AMENDMENT NO. 1 NOVEMBER 1997
TO
IS 3075 (PART 2) : 1986 SPECIFICATION FOR CIRCLIPS
PART 2 FOR BORES

(First Revision)

FIG. 2 BEND TEST AND FRACTURE TEST

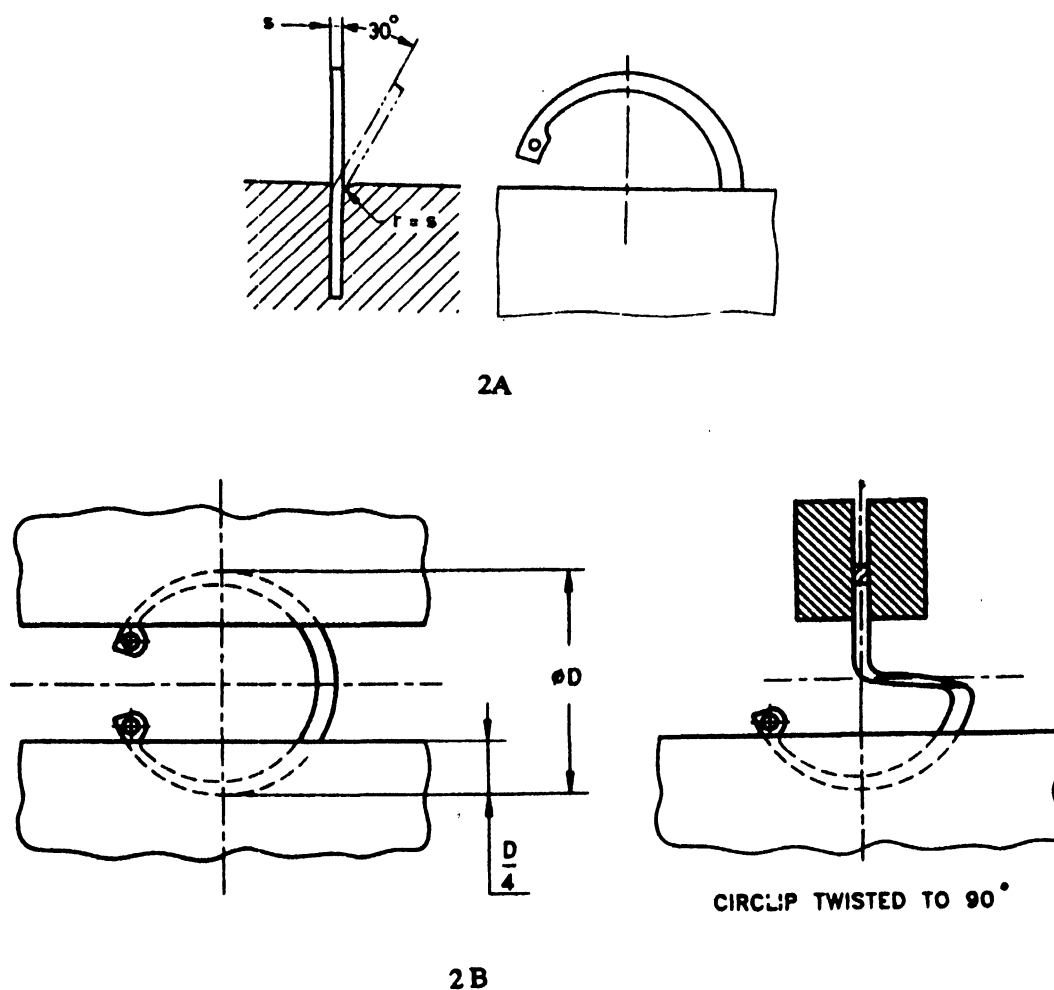
(Page 6, clauses 7.2 to 7.2.2) — Substitute the following for the existing clauses:

(Page 6, Fig. 2) — Delete.

7.2 Bend Test and Twist Test

7.2.1 Bend test

The circlip shall be clamped between two jaws, of which one has a radius equal to the thickness of the circlip as shown in Figure 2A. The circlip is bent through 30° by repeated light hammer blows or with a lever, following which there shall be no fracture or cracks in the circlip. The circlip is then further bent until fracture occurs. The fracture surface shall reveal a fine-grained structure.

7.2.2 Twist test

The circlip shall be clamped so that 3/4 of its diameter is free as shown in the Figure 2B. An equivalent section of the circlip shall be gripped and rotated through 90° following which there shall be no signs of fracture, cracks or similar defects. The circlips shall then be further twisted in the direction until fracture occurs, following which examination of the fracture shall reveal a uniform grain structure with no sign of lamination or other defects.
